WisDOT Bridge Manual January 2023 Updates

James Luebke, P.E.
Policy and Standards Engineer
March 1, 2023

Bridge Manual Users DTSD – Bureau of Structures SUBJECT: January 2023 Bridge Manual Update

Chapter 40 – PPC Overlay Criteria

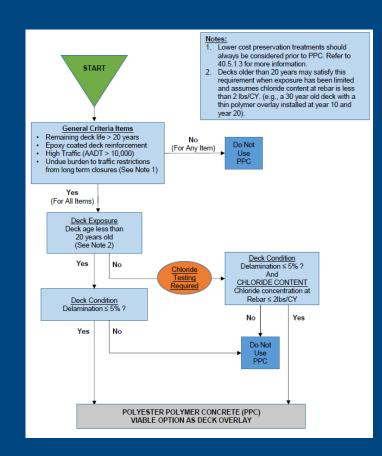
- Chapter 40 PPC Overlay Criteria
 - New criteria expands PPC overlay eligibility
 - ■PPC should not be used unless lower cost preservation treatments (e.g. thin polymer overlays) have proven ineffective.
 - Other factors that may affect approval: Proximity to other high ADT roadways, Backbone/Interstate, Preservation of slab structure

■ NBI:

7 **→** 6

■ Deck Exposure:

15 years → 20 years

AADT:

20,000 **→ 10,000**

■ Chloride Content: 5 lbs/CY → 2 lbs/CY
